PRELIMINARY PLAN

PINE CANYON CONDO - BUILDING 1

OWNER: PINE CANYON LODGE
PROJECT: PINE VALLEY CONDOMINIUMS
LOCATION: 3567 NORDIC VALLEY WAY, EDEN, UTAH 84310
© vanZeben Architecture. This drawing shall not be reproduced without consent of vanZeben Architecture, nor shall it be used for any project other than the originally intended project.

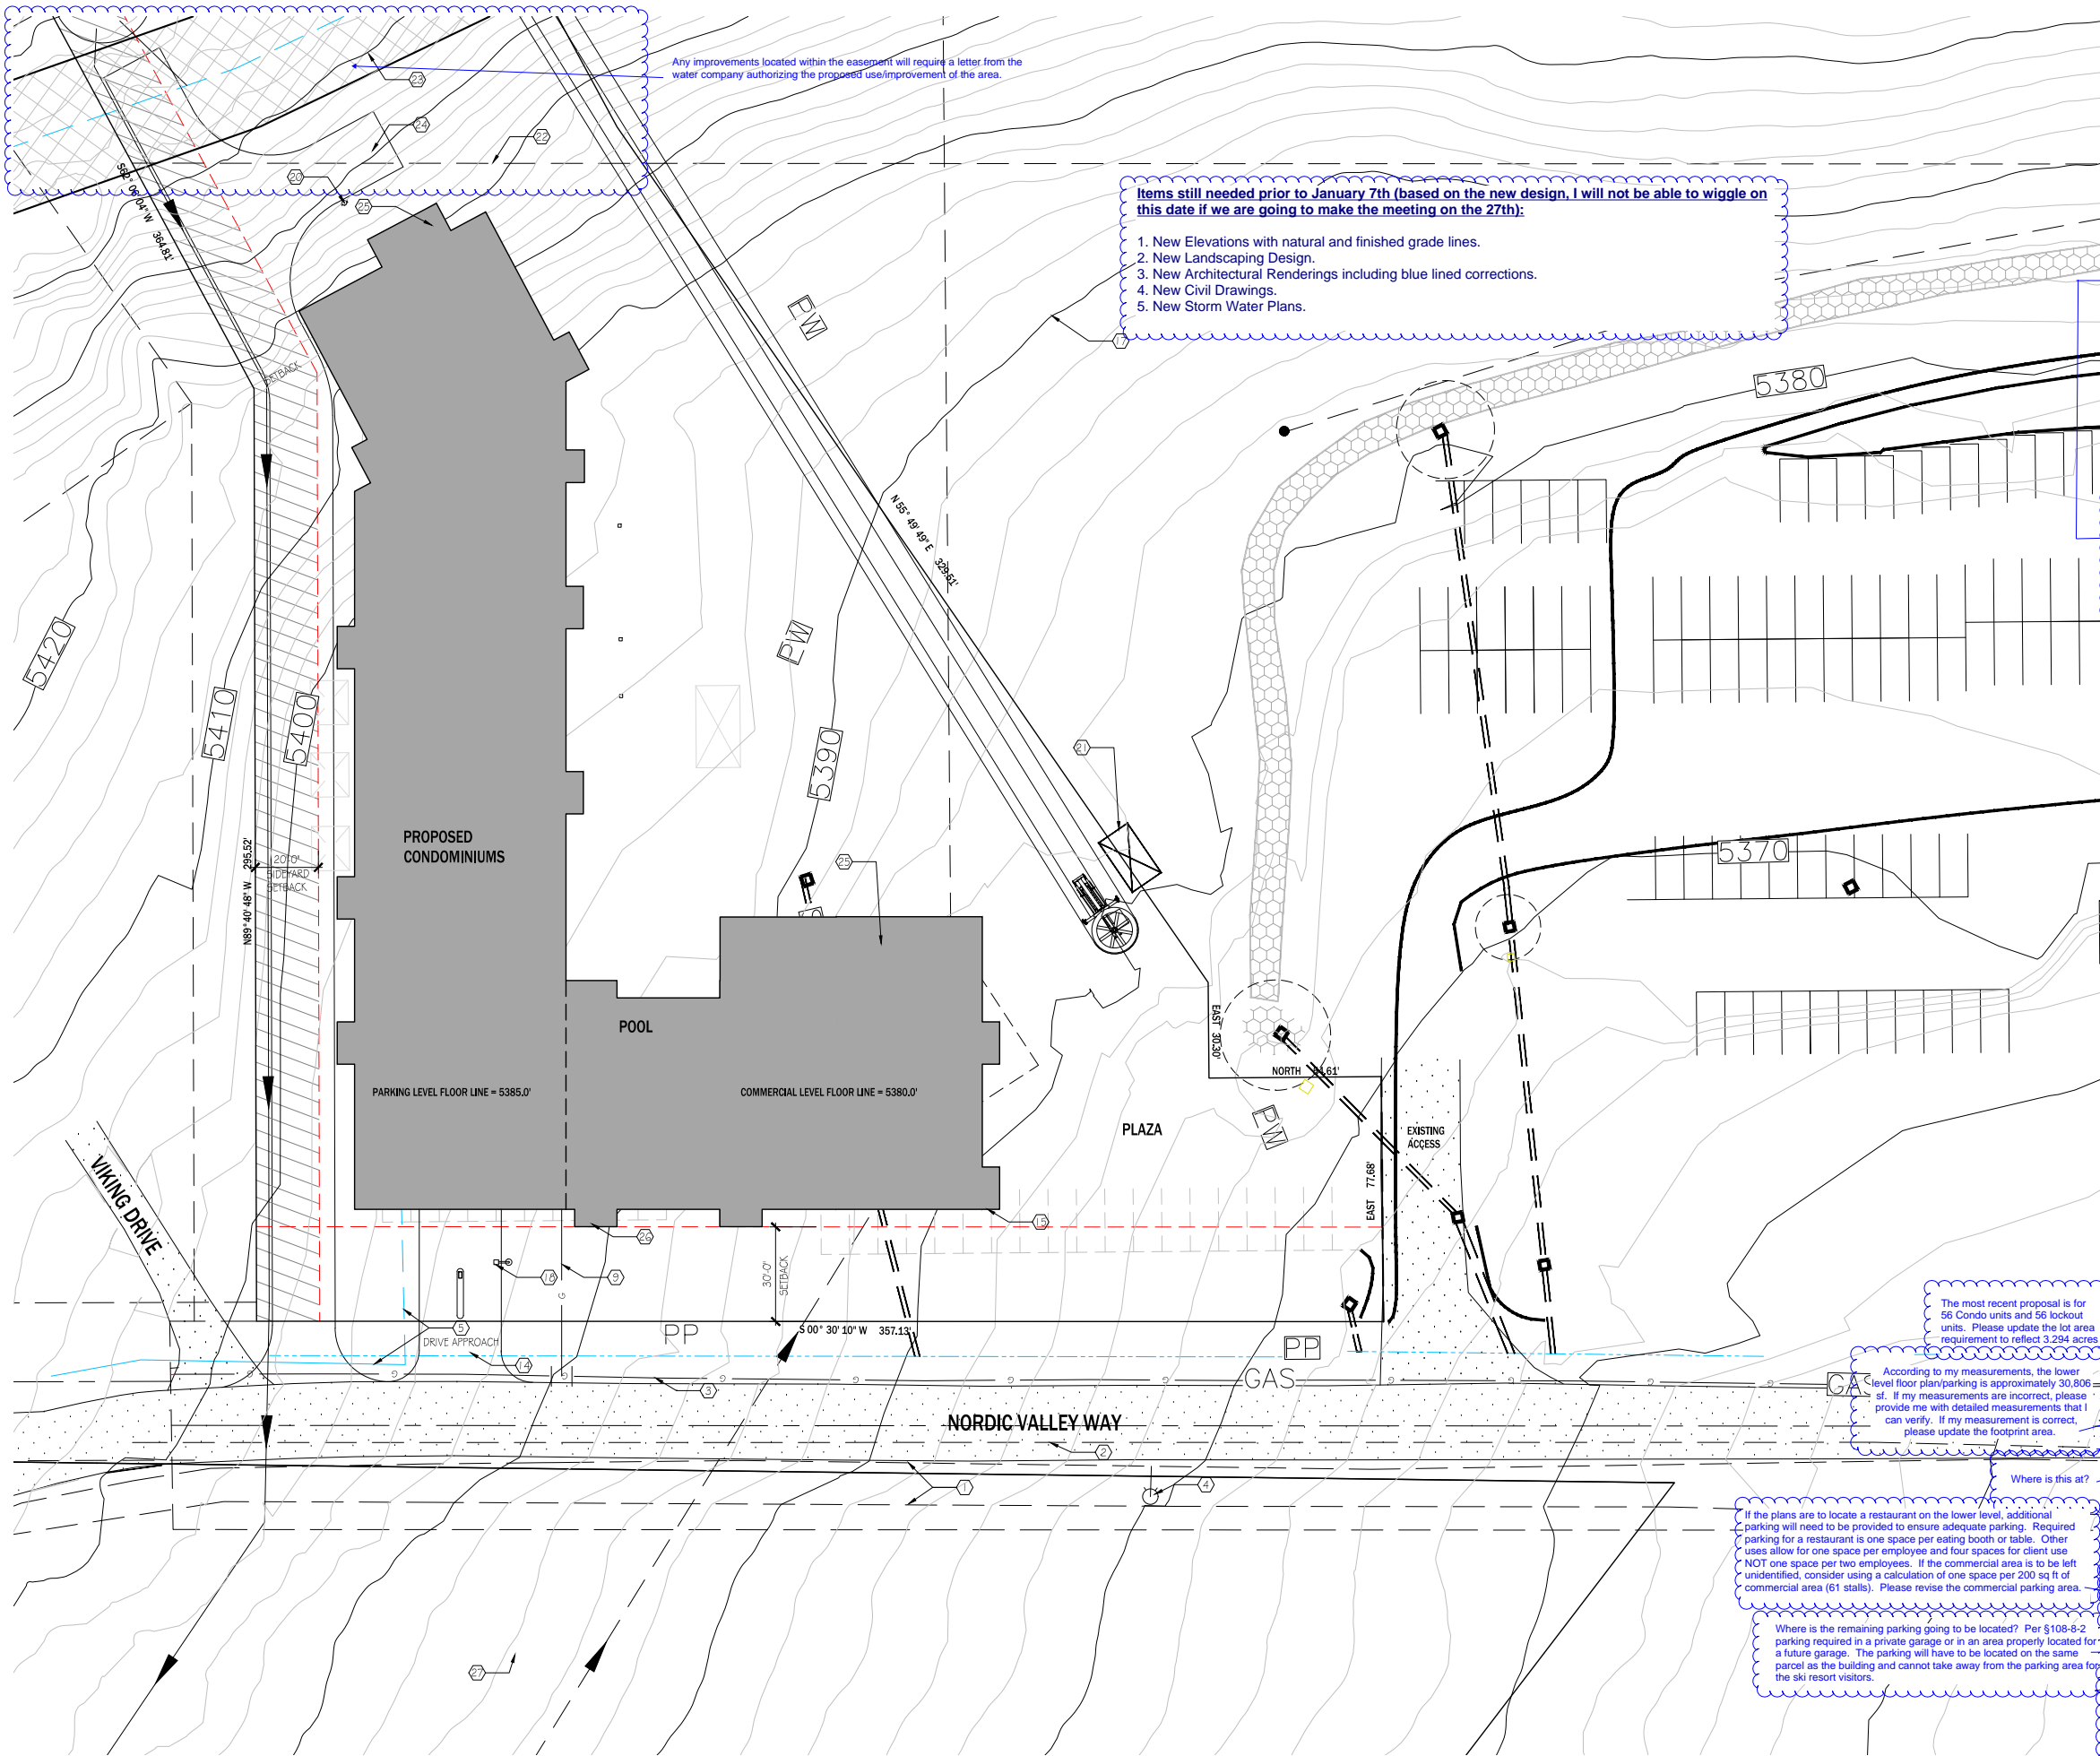
The most recent Architectural Drawings have identified 56 Condo Units and 56 Lockout Rooms. The area requirement for that amount of units is 143,500 SF (3.294 Acres). Please revise the Boundary Description to reflect the accurate area requirement per the amount of units requested.

1
138,500-S.F.
3.180-ACRES
143,500 SF
3.294 Acres

SITE PLAN
AS101 SCALE: 1" = 20'-0"

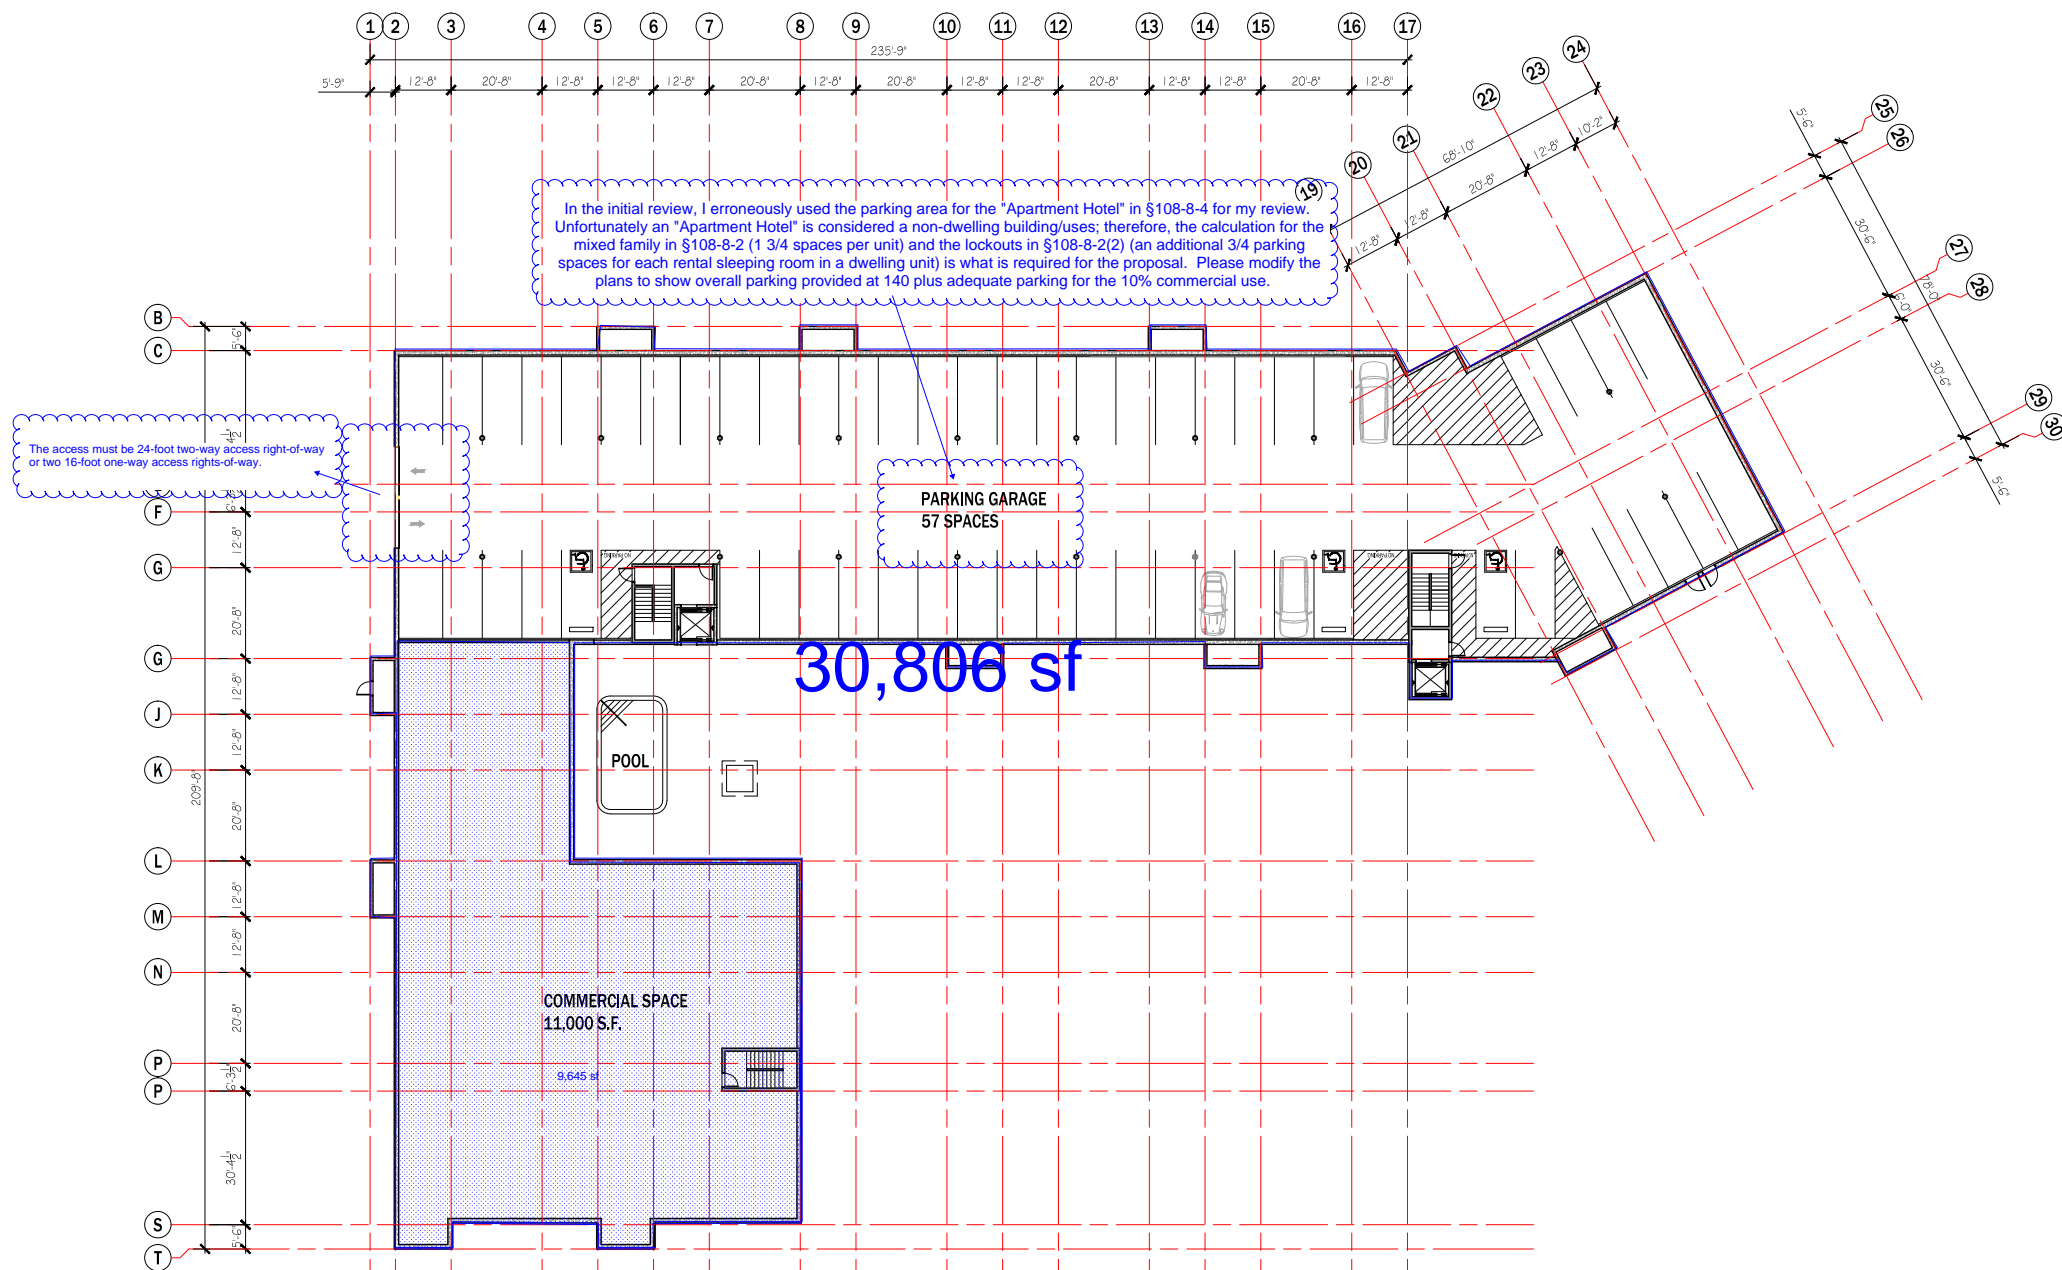
16. The previous plans identified a temporary dumpster location. The current plans do not identify a trash dumpster location. Trash dumpsters including the enclosure/screening are required to be shown on the site plans for approval.

Any improvements located within the easement will require a letter from the water company authorizing the proposed use/improvement of the area.

In the initial review, I erroneously used the parking area for the "Apartment Hotel" in §108-8-4 for my review. Unfortunately an "Apartment Hotel" is considered a non-dwelling building/uses; therefore, the calculation for the mixed family in §108-8-2 (1 3/4 spaces per unit) and the lockouts in §108-8-2(2) (an additional 3/4 parking spaces for each rental sleeping room in a dwelling unit) is what is required for the proposal. Please modify the plans to show overall parking provided at 140 plus adequate parking for the 10% commercial use.

The most recent proposal is for 56 Condo units and 56 lockout units. Please update the lot area requirement to reflect 3,294 acres

According to my measurements, the lower level floor plan/parking is approximately 30,806 sf. If my measurements are incorrect, please provide me with detailed measurements that I can verify. If my measurement is correct, please update the footprint area.

Where is this at?

If the plans are to locate a restaurant on the lower level, additional parking will need to be provided to ensure adequate parking. Required parking for a restaurant is one space per eating booth or table. Other uses allow for one space per employee and four spaces for client use NOT one space per two employees. If the commercial area is to be left unidentified, consider using a calculation of one space per 200 sq ft of commercial area (61 stalls). Please revise the commercial parking area.

Where is the remaining parking going to be located? Per §108-8-2 parking required in a private garage or in an area properly located for a future garage. The parking will have to be located on the same parcel as the building and cannot take away from the parking area for the ski resort visitors.
